VENUE CYMRU, LLANDUDNO

AUDIOVISUAL SYSTEMS - PAGING

GROUND FLOOR WHOLE SITE

CLIENT MARKUP

Scale	Size	Status	
NTS	A1	Tender	
Drawn	Date	Checked	Date
DB	10/10/25	JN	05/11/2025
DRAWING NUMBER			REV
LVC-CBL-PAG-GA-009			A

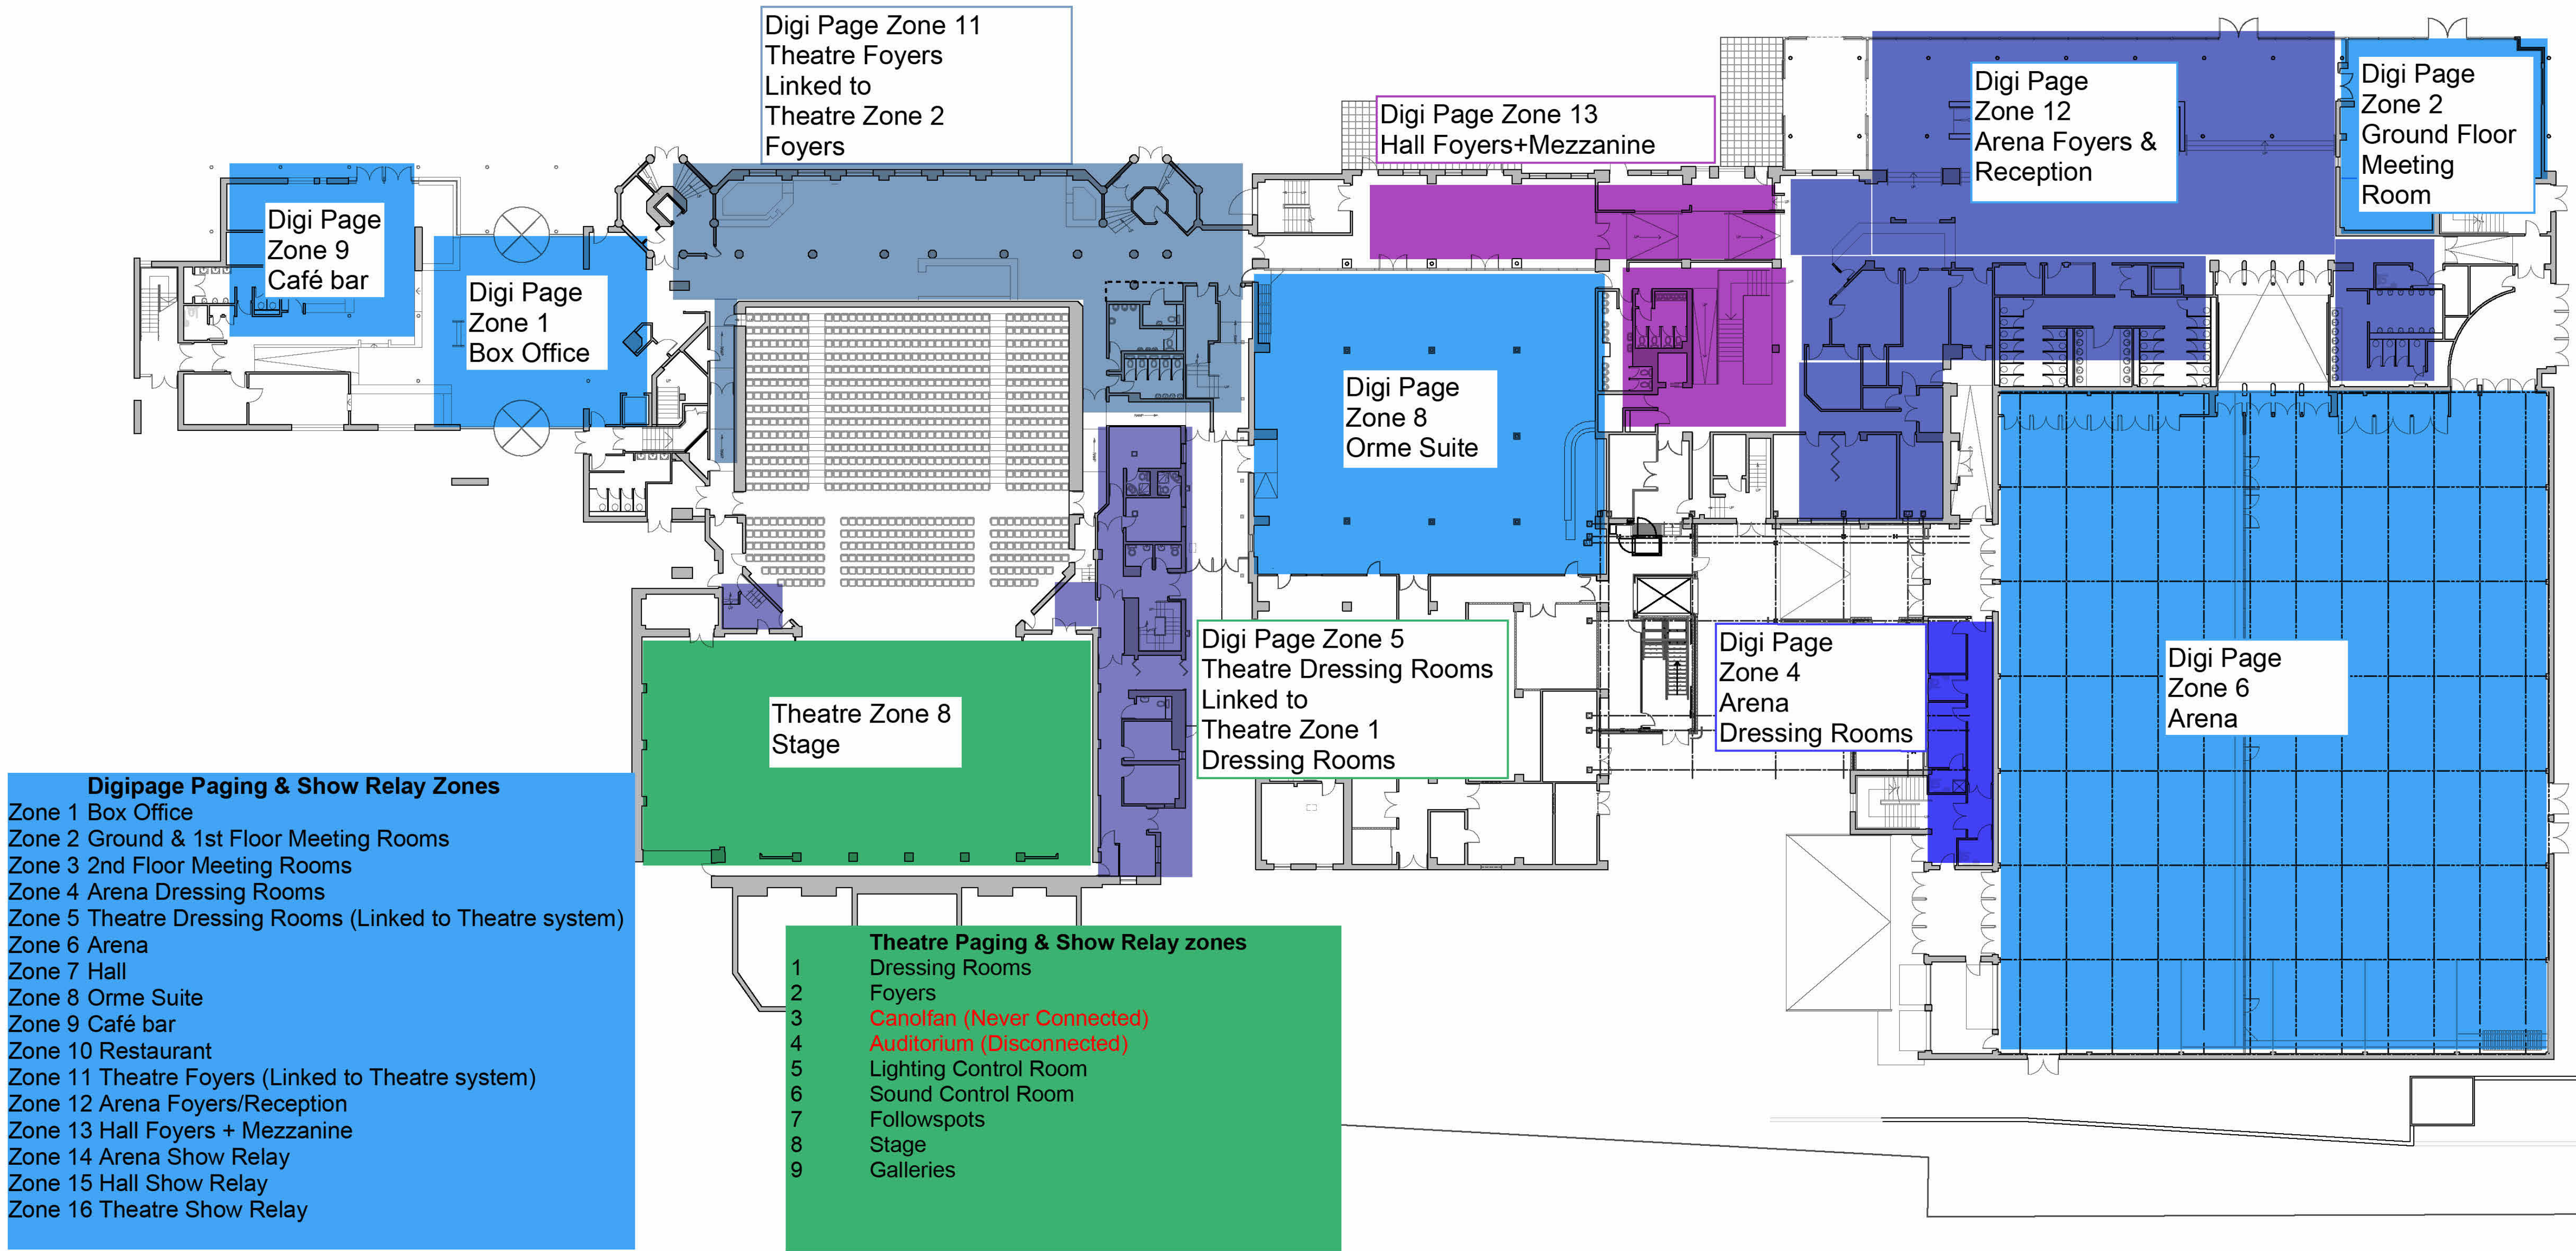
This markup provided by the client (Venue Cymru) indicates the coverage and zoning of the 2 existing paging systems at Venue Cymru, referred to in Charcoalblue documentation as:

There are links between the 2 systems
Digipage Zone 11 and Theatre Zone 2 are the Theatre Foyers
Digipage Zone 5 and Theatre Zone 1 are the Theatre Dressing Rooms.

The Charcoalblue design for the paging system will replace the entire control system, and the existing backstage paging for the theatre.

The Digipage **control** system is required to be decommissioned and control of the amplifiers, loudspeakers and Arena show relay will be via the new control system.

The Front of House theatre zone 2 is fed covered by a PAVA system which the client advises is not up to current standards.

The specialist contractor as part of this tender should seek suitable guidance from a Fire Consultant on whether the PAVA amplifiers and loudspeaker system is still suitable for purpose and advise the client of the best solution to maintain a front of house announcement system.

Venue Cymru will be having additional work to remodel part of the front of house areas in the coming years, therefore it is advised that when this work takes place, the paging system for front of house is updated as part of that work.
